Subject: Duke Energy Corporation  
Oconee Nuclear Station - Units 1, 2, and 3  
Docket Nos. 50-269, 50-270, and 50-287

Revisions to Topical Report DPC-NE-3003 In Support of  
Steam Generator Replacement  
Response to NRC Staff Request for Additional  
Information

Enclosed herein, please find the Duke Energy Corporation (Duke) response to the May 12, 2003 NRC staff's request for additional information concerning topical report DPC-NE-3003, Revision 1, "Mass and Energy Release and Containment Response Methodology."

### **Duke Power Response To Request For Additional Information**

**GOTHIC 7.0 - FATHOMS COMPARISON**  
**ROTSG STEAM LINE BREAK**  
**(1.0 ft<sup>2</sup> Break with SG Level Controlled to 90")**

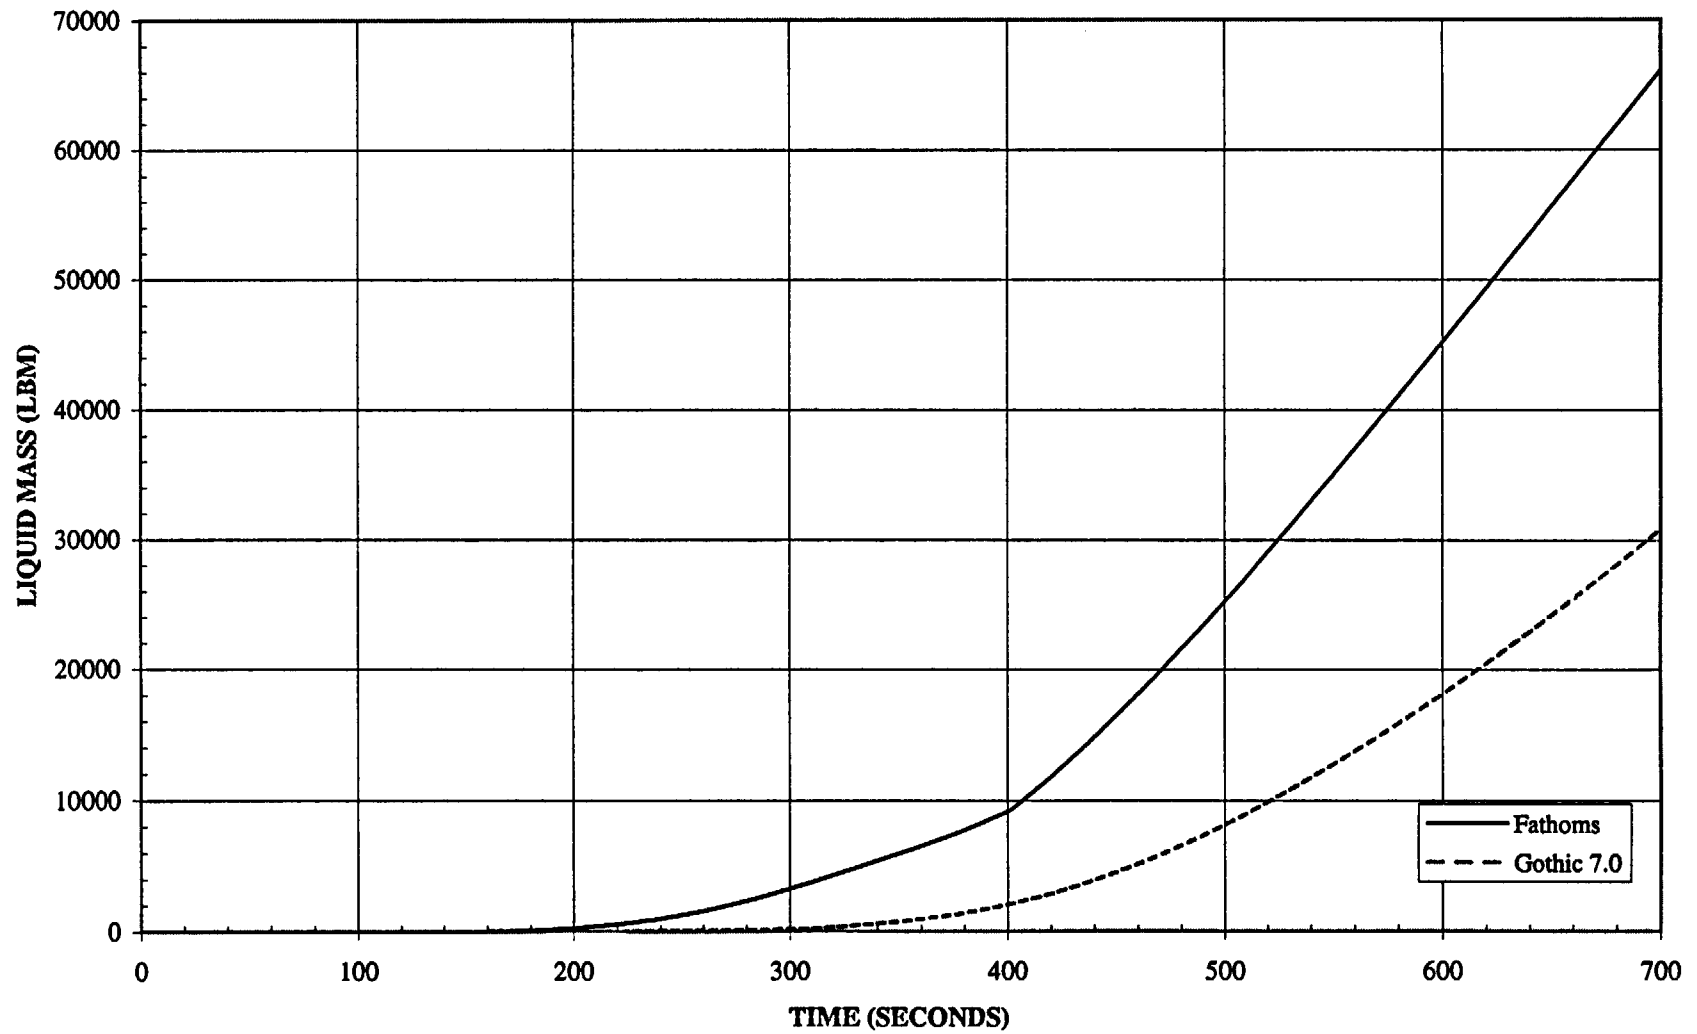
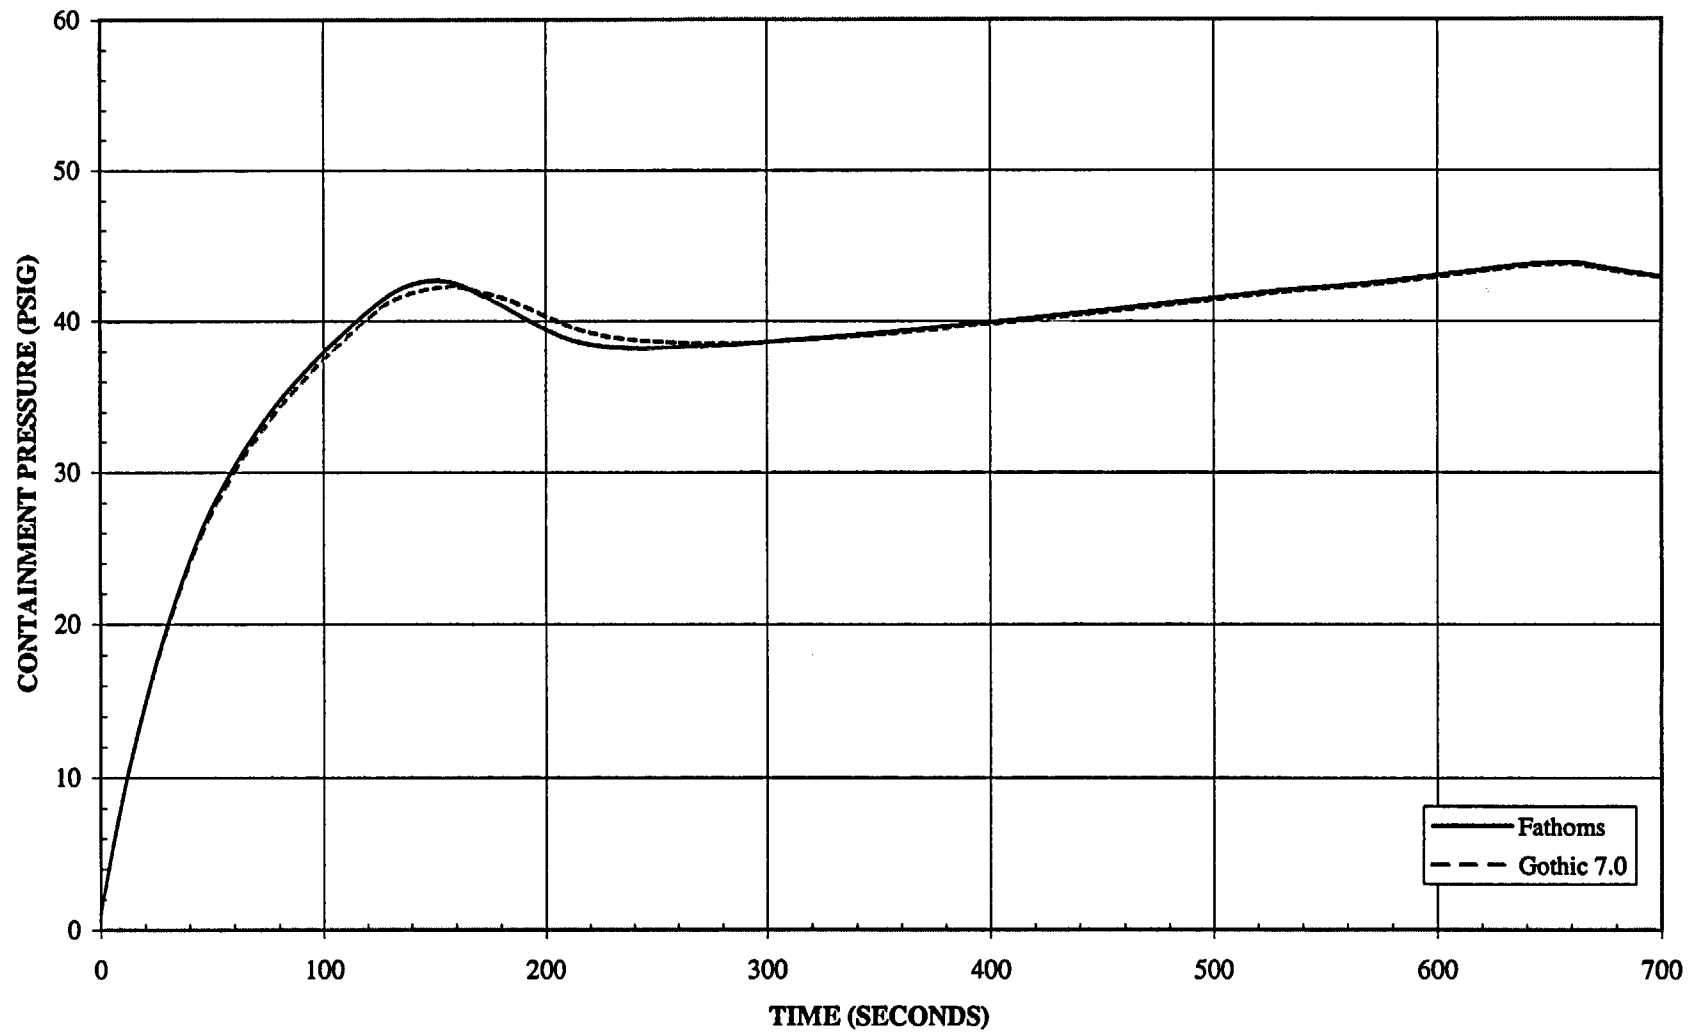
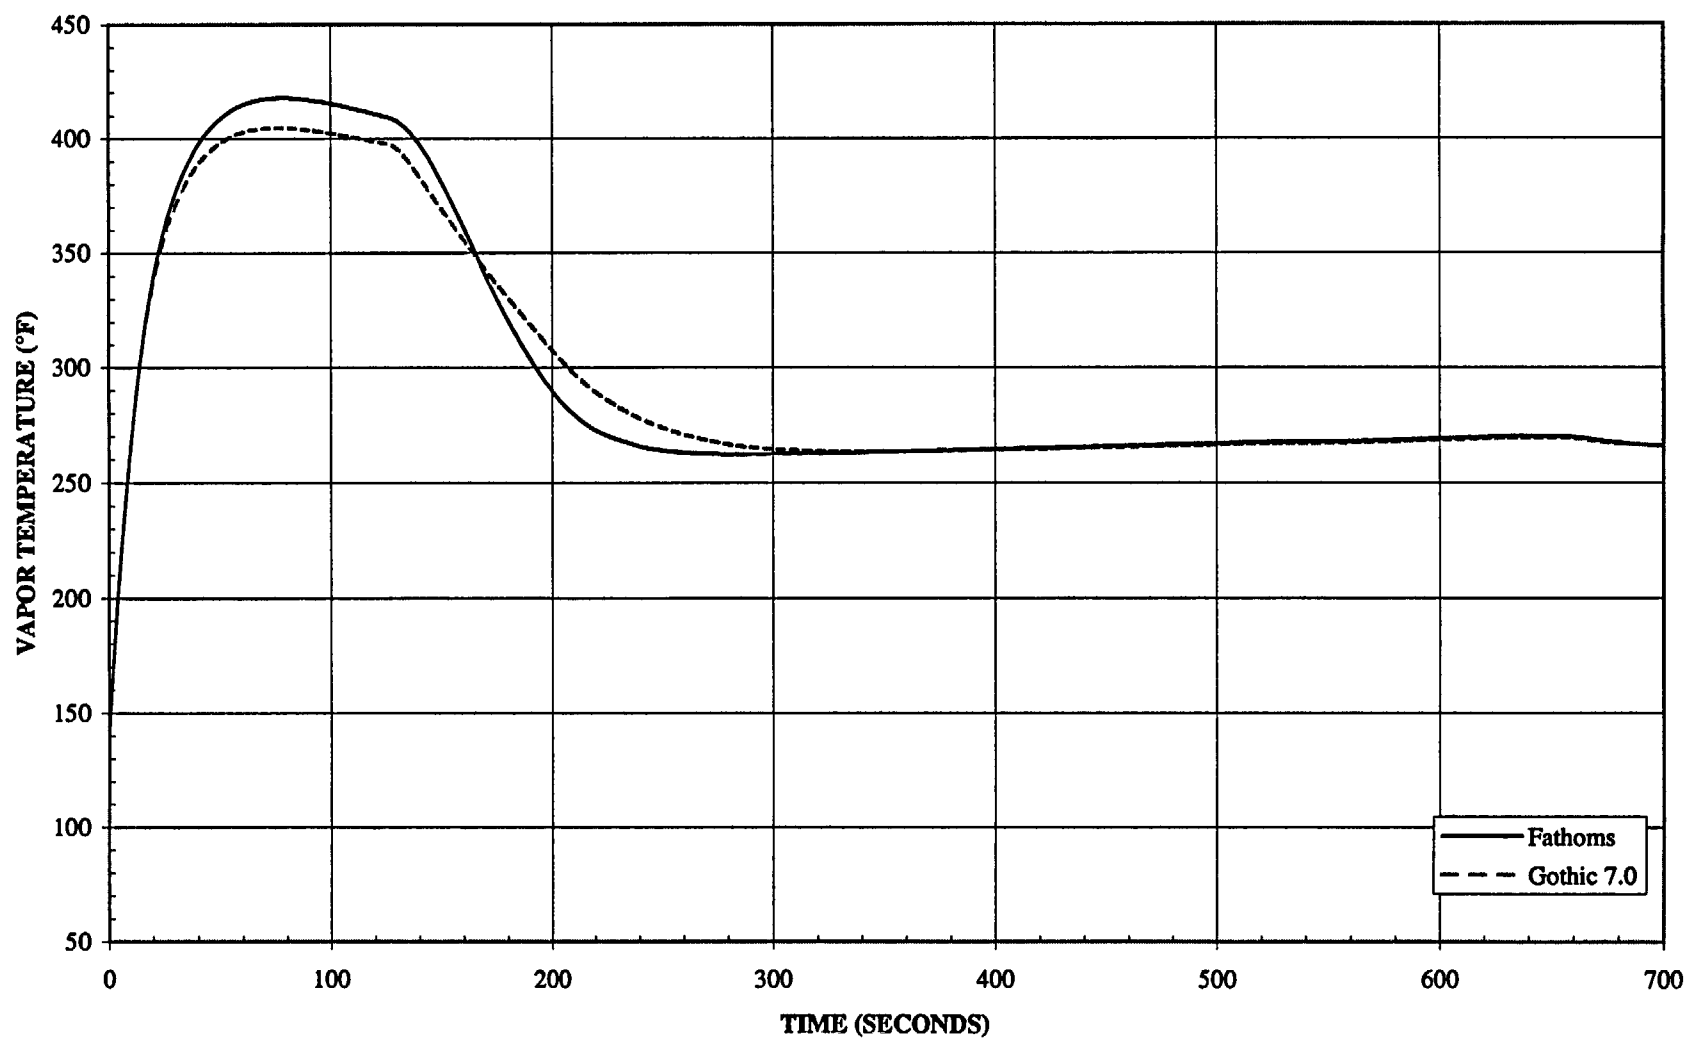
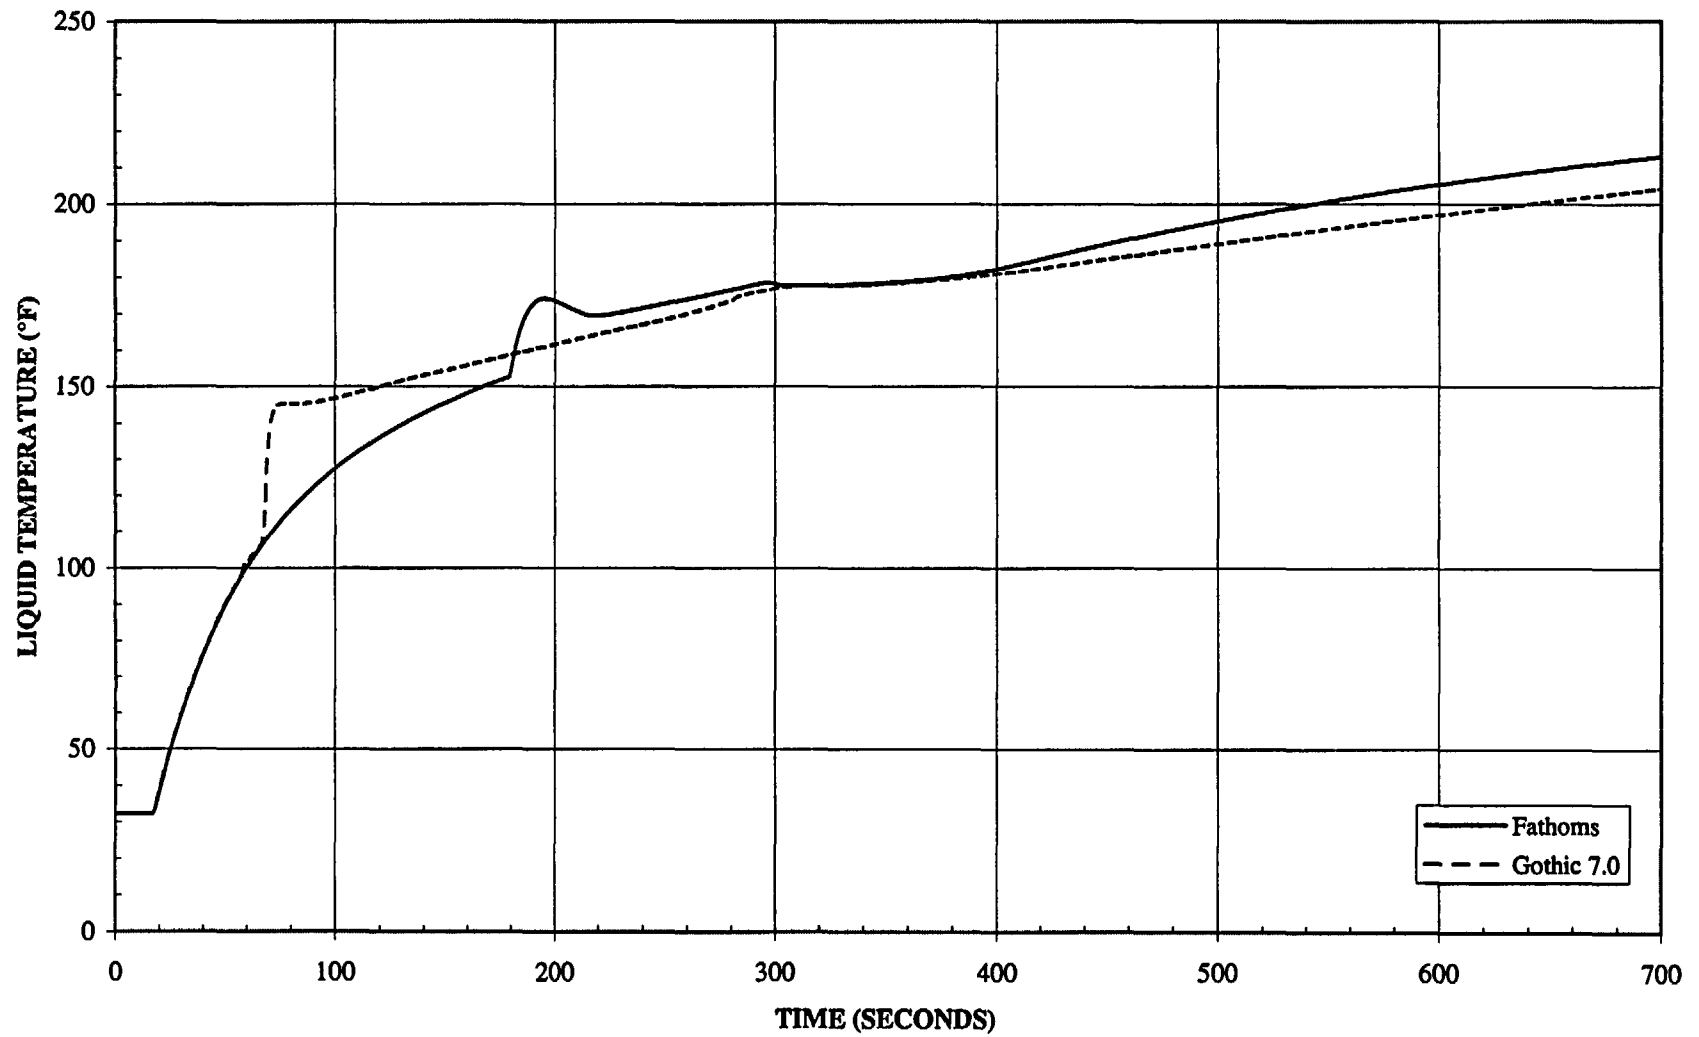
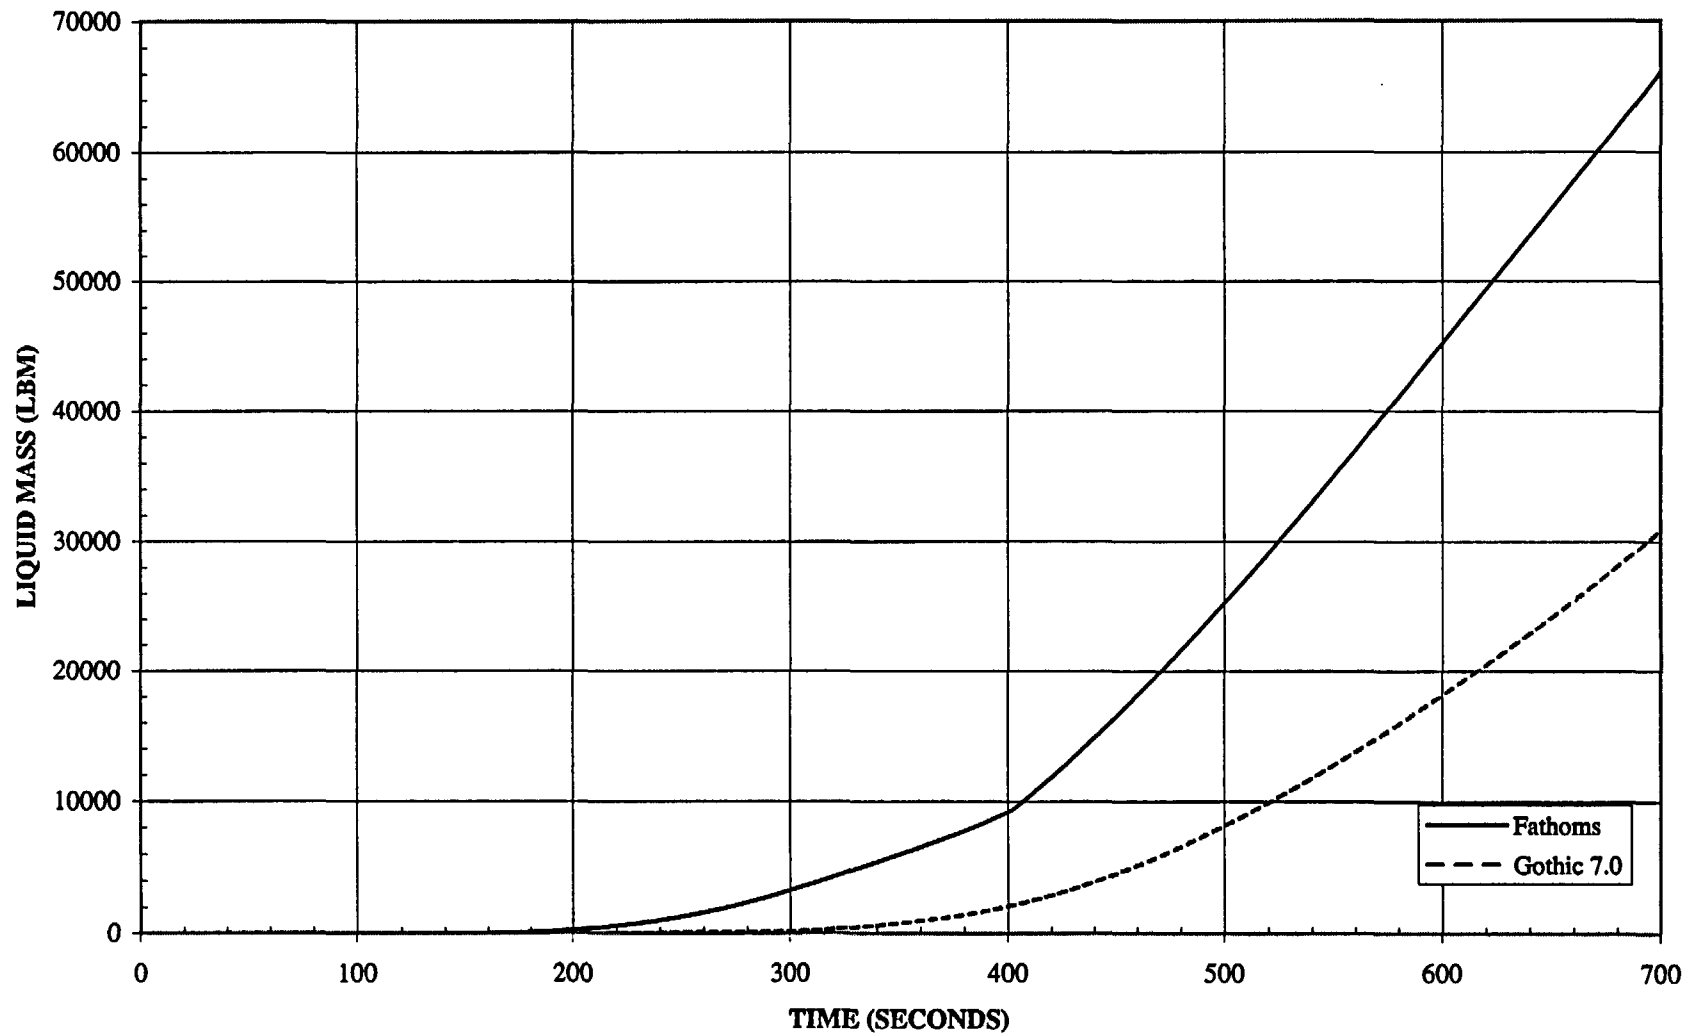
14. Show that GOTHIC and FATHOMS calculations result in the same pressures, temperatures, sump temperatures, etc. for the design basis LOCA and main steam line break events. If they do not, explain differences in terms of the differences in models between the two codes. (See Question 1.)

Response: Refer to the response to Question #3 for LOCA. The results of the 6 code comparison analyses for the main steam line break are given in Table 14-1 and the figures that follow. The containment response following a main steam line break event for the ROTSG was performed to compare the results from FATHOMS 2.4 and GOTHIC 7.0. In general, the pressure and vapor temperature responses are very similar. GOTHIC 7.0 predictions for peak pressures are slightly lower on the smaller break sizes (~0.3 psi) and slightly higher for larger break sizes (~0.95 psi). The peak vapor temperature responses predicted by GOTHIC 7.0 overall are slightly lower (~12°F). For larger break sizes, the higher pressure predicted by GOTHIC 7.0 may be attributed to additional steam generation from the improved interface heat and mass transfer models and from the drops that are generated due to dripping. The slightly lower pressure for smaller break sizes may be attributed to additional droplets in the atmosphere. The slightly lower vapor temperature and liquid temperature in GOTHIC 7.0 for all break sizes may be attributed to additional droplets in the atmosphere also. This effectively increases the heat capacity of the atmosphere and reduces the temperature rise for a given energy addition. As discussed in the responses to Questions #1 and #3, more liquid is predicted to remain in droplet form in GOTHIC 7.0 which results in less liquid mass in the sump. In addition, the lower sump temperature predicted by GOTHIC 7.0 may be attributed to the addition of the second energy equation for the drops and the improved heat and mass transfer models in GOTHIC 7.0.
